File: 04-SF-1/101
Doyle Dr. Project Contract 3
04-163733

Subject: Request for Contract Change Order

This is to initiate a Contract Change Order request for replacing the light pedestal, VMS sign, construction signs to accommodate the Presidio Trust request and recommendation. (Please check all applicable boxes):

Brief Description of Work: Brief Description
Replacing the standard light poles and VMS signs to a new custom design.
This Contract Change Order is necessary due to the following: Why Change?
To accommodate the Presidio Trust request. Construction will resolve any cost related issue created by this CCO with the contractor in the field.

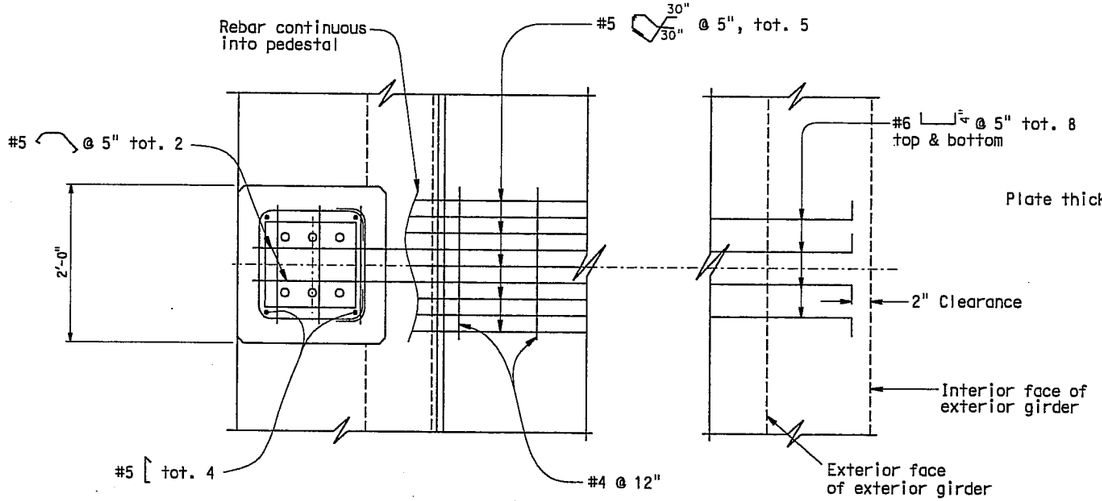
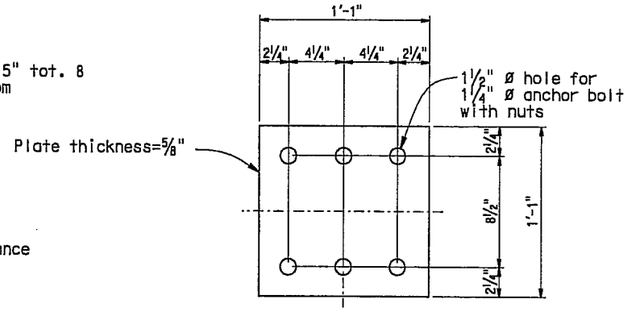
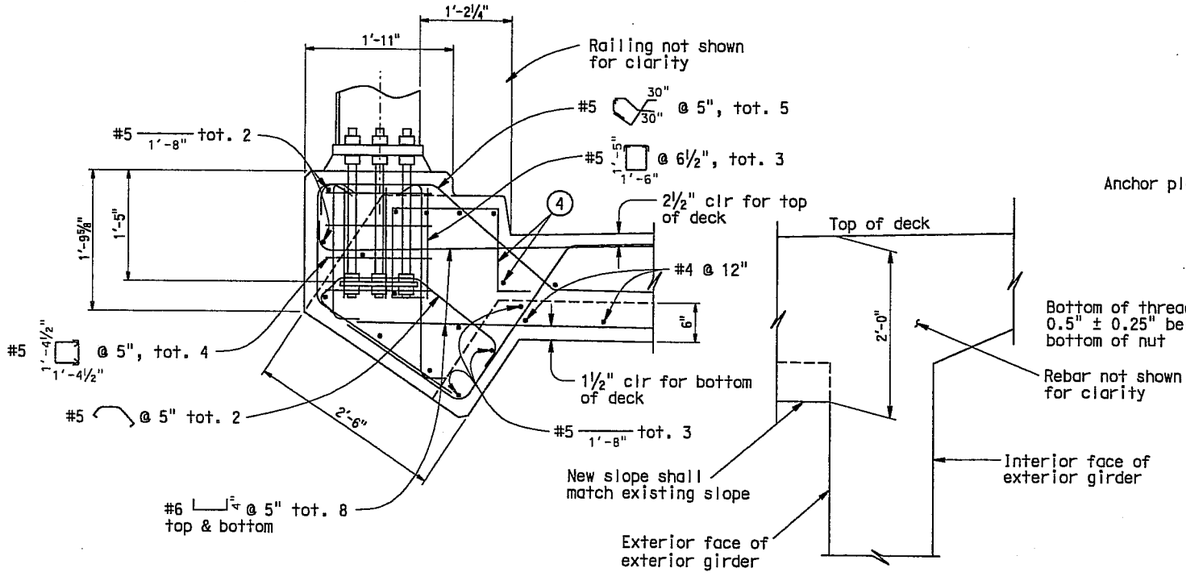
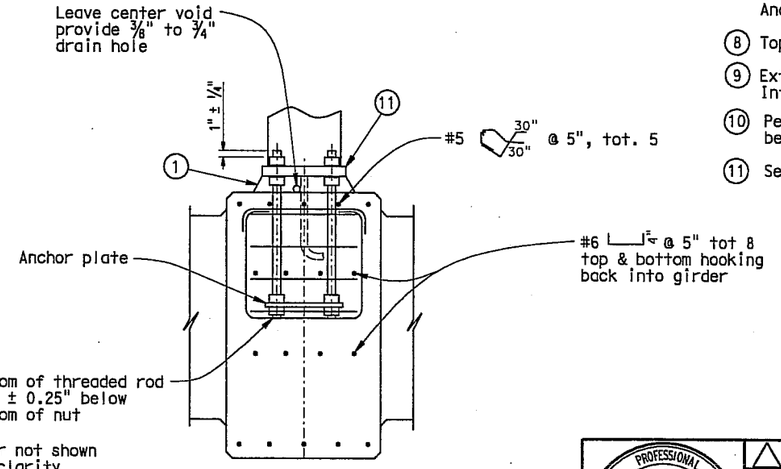
MARK	DATE	REVISION(S) DESCRIPTIONS	DES	CHK	DET
1	3-10-10	Revised Entire sheet	RB		DJ

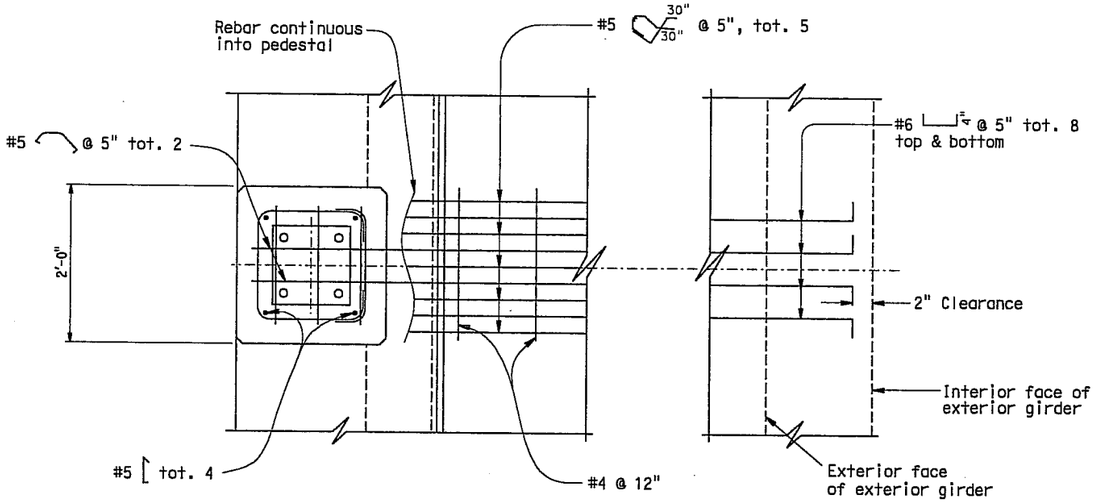
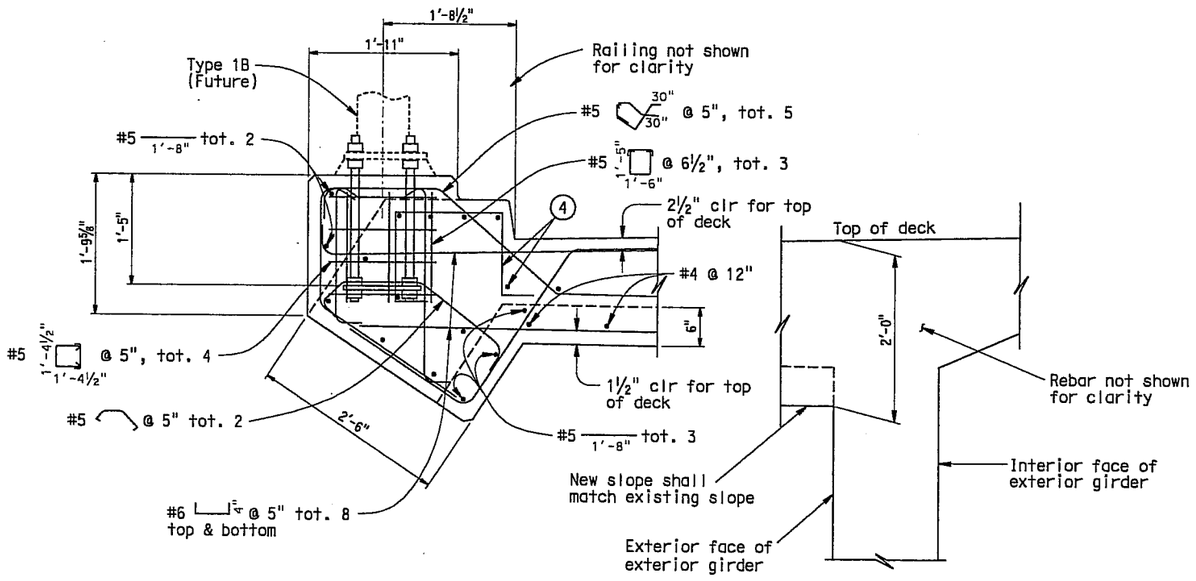
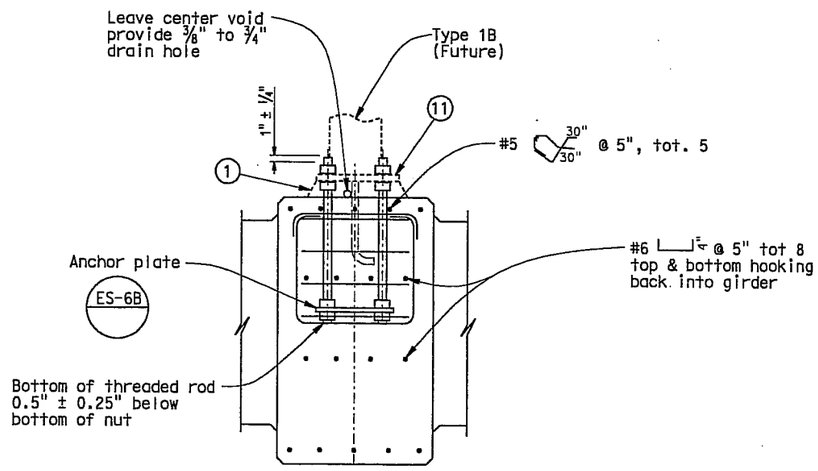
MARK	DATE	REVISION(S) DESCRIPTIONS	DES	CHK	DET
1	3-10-10	Revised Entire sheet	RB		DJ

ELEVATION
PERMANENT SIGN 113

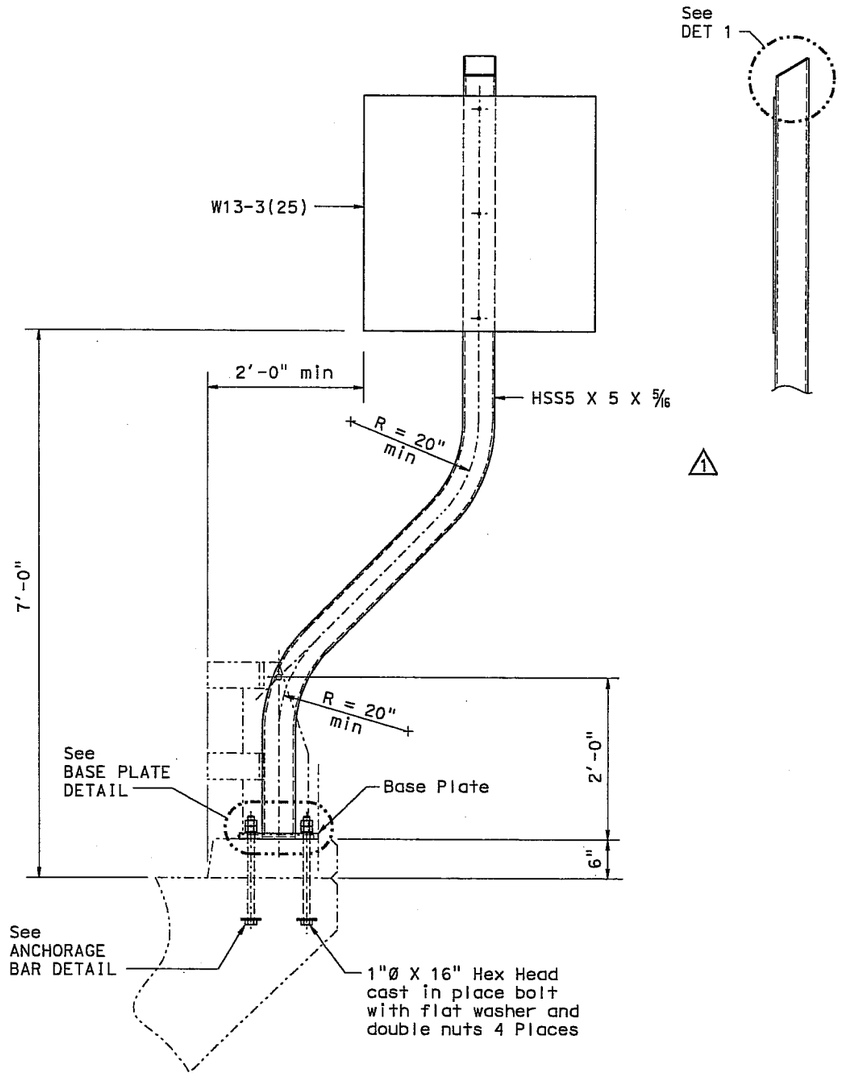
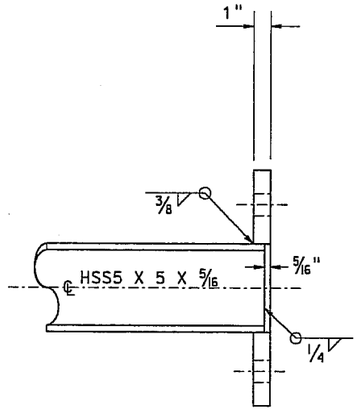
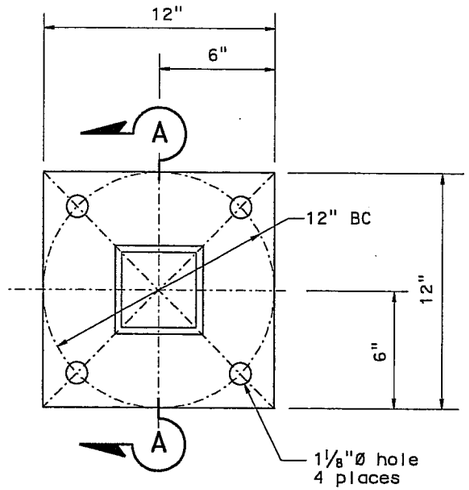
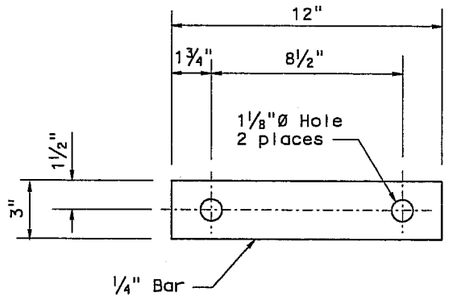
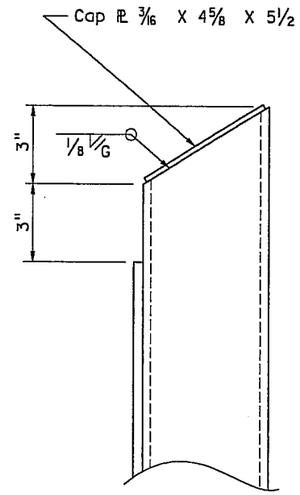
MARK	DATE	REVISION(S) DESCRIPTIONS	DES	CHK	DET
1	3-10-10	Revised Details and Added Detail 1	LM		AD

ELEVATION
PERMANENT SIGN 114, 115 & 116

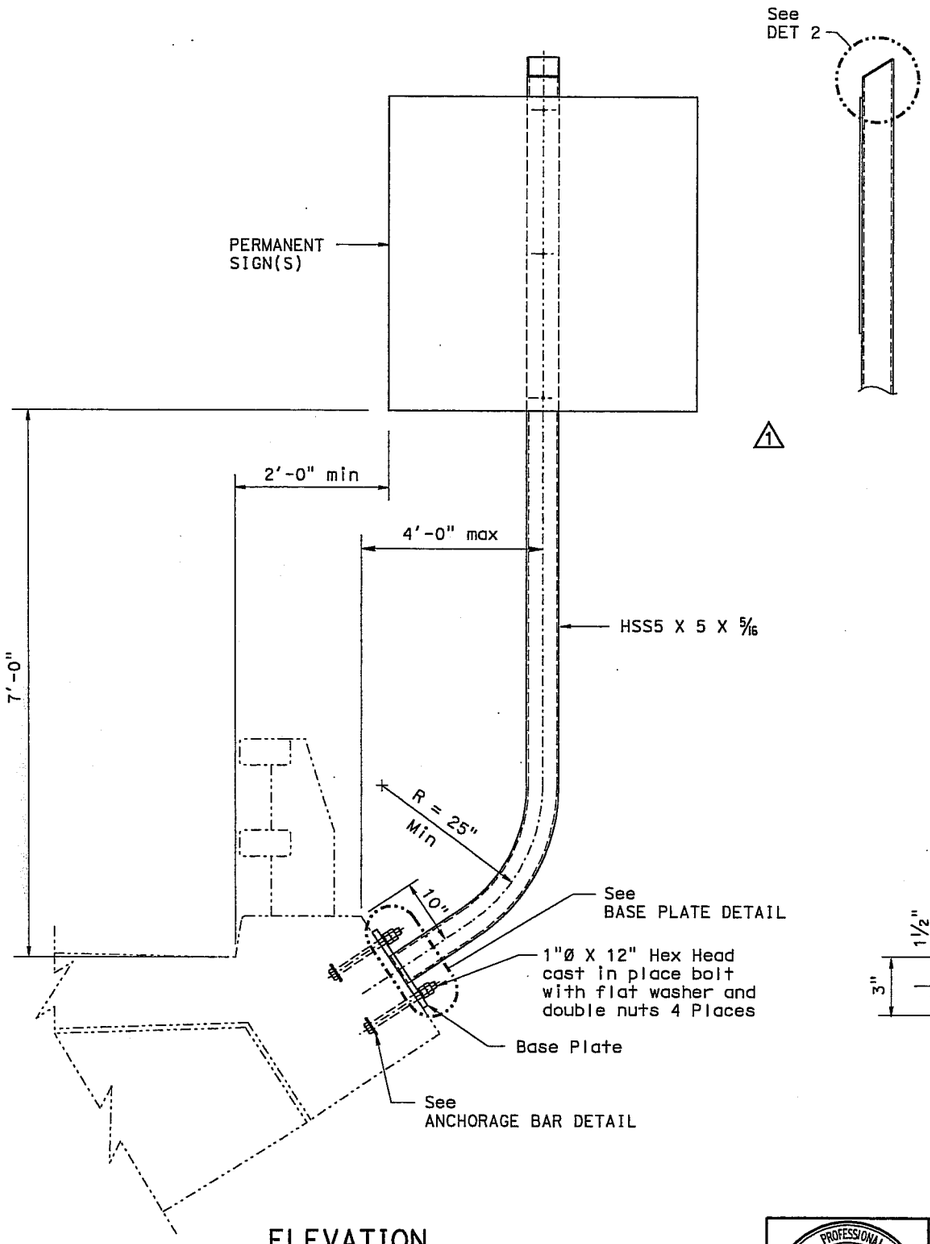
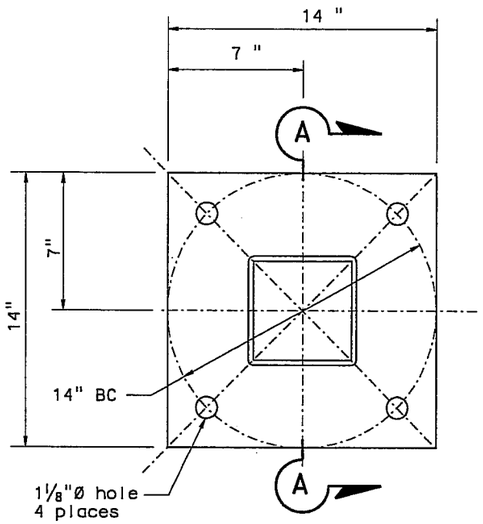
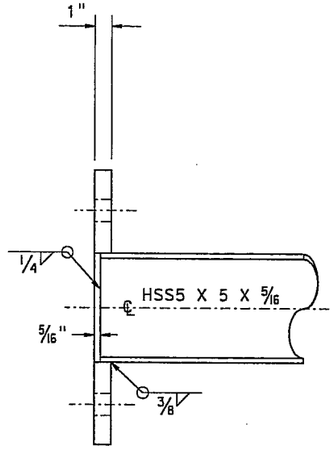
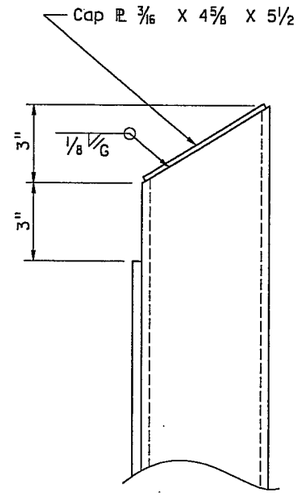
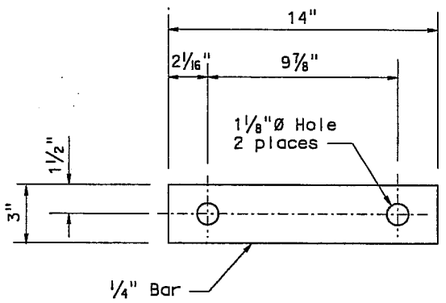
MARK	DATE	REVISION(S) DESCRIPTIONS	DES	CHK	DET
1	3-10-10	Revised Details and Added Detail 2	LM		AD

STAGE CONSTRUCTION SIGN 4 ⚠1

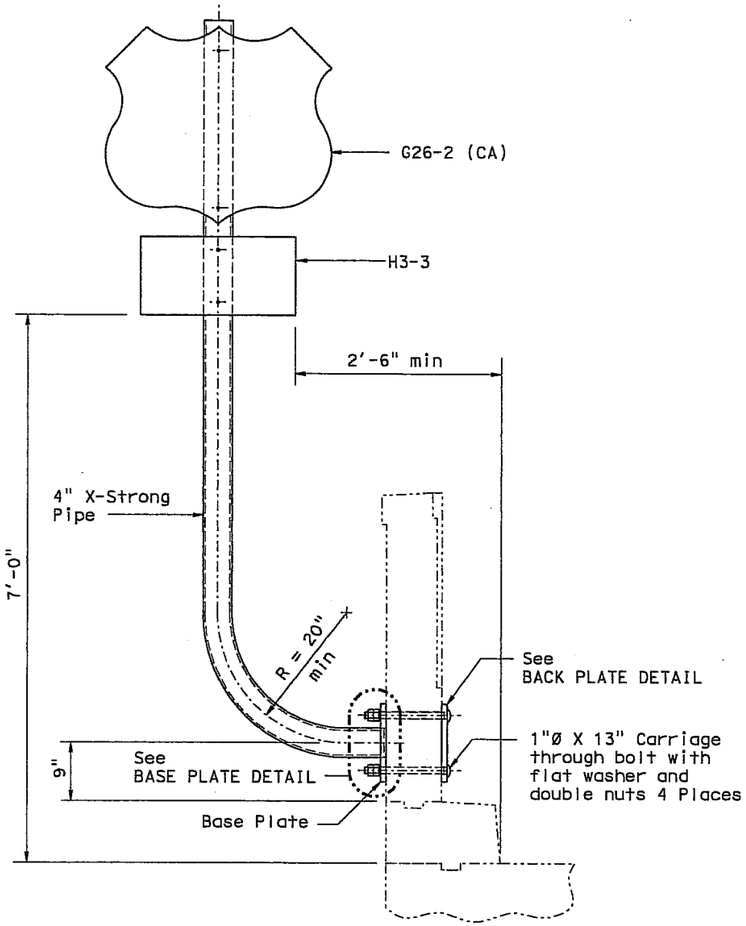
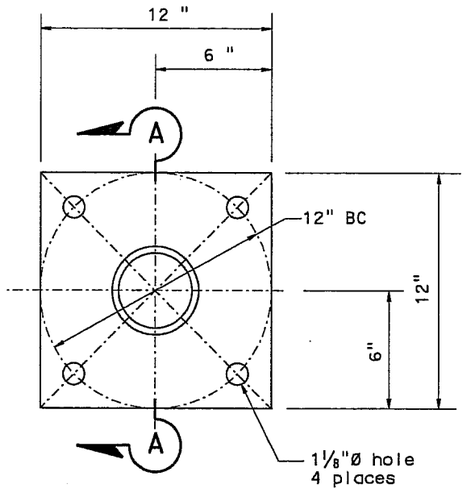
MARK	DATE	REVISION(S) DESCRIPTIONS	DES	CHK	DET
1	3-11-10	Revised sign type	LM		AD

STAGE CONSTRUCTION SIGN 4 & 17 ⚠1

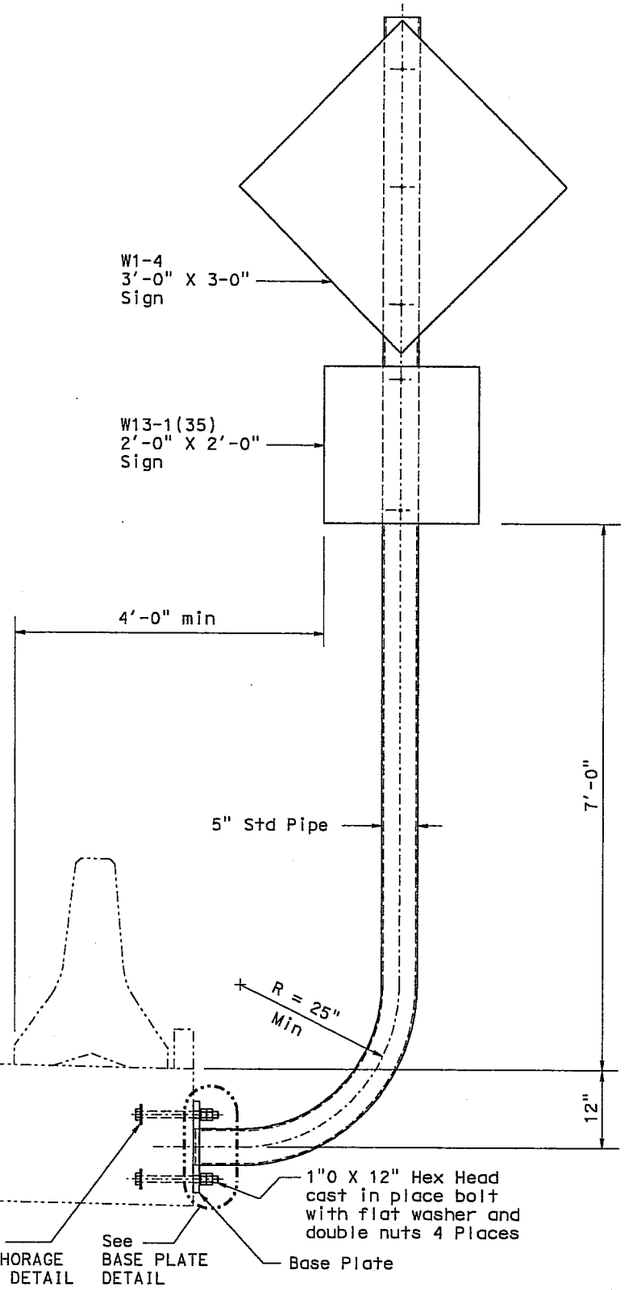
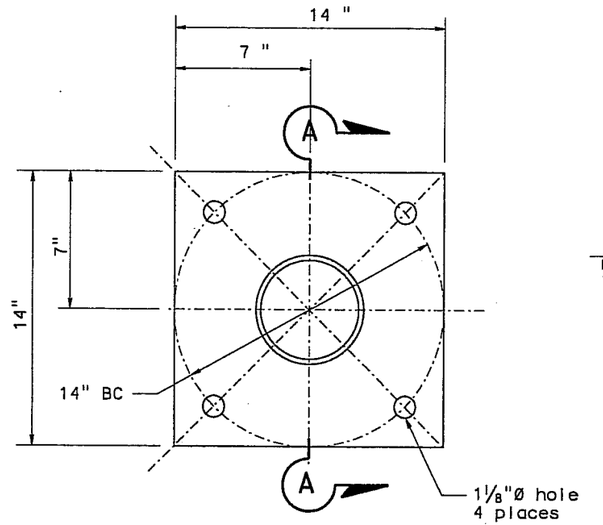
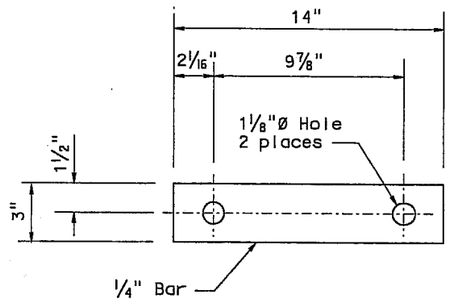
MARK	DATE	REVISION(S) DESCRIPTIONS	DES	CHK	DET
⚠1	3-11-10	Revised sign type	LM		AD

PEDESTAL FOR CUSTOM LIGHT FIXTURE
N1-S101 CONNECTOR

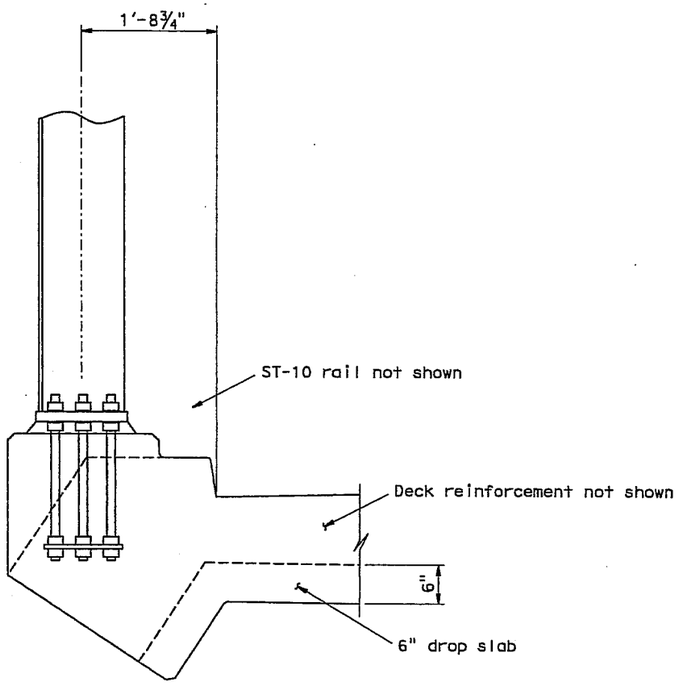
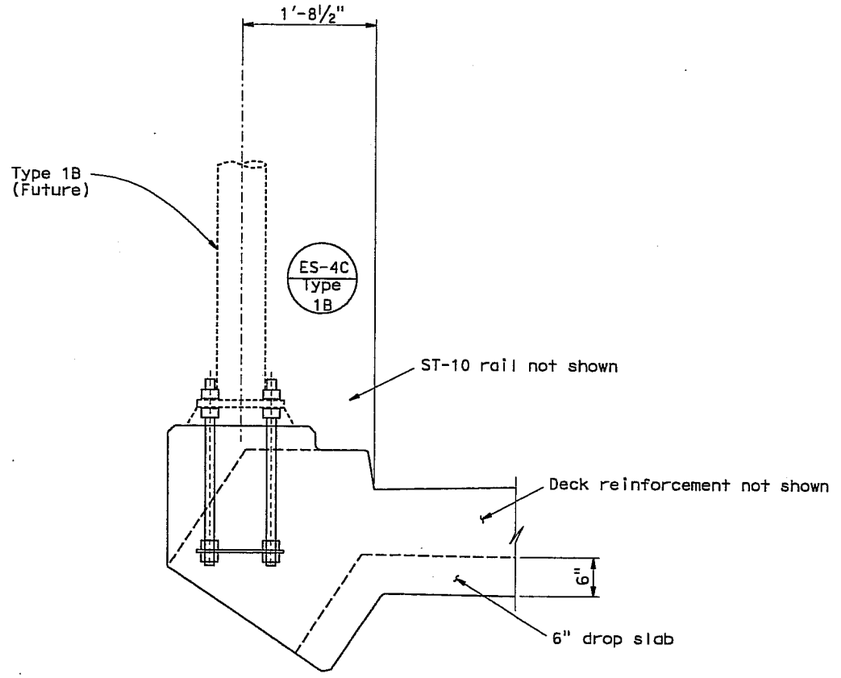
MARK	DATE	REVISION(S) DESCRIPTIONS	DES	CHK	DET
1	3-10-10	Revised Entire sheet	RB		DJ
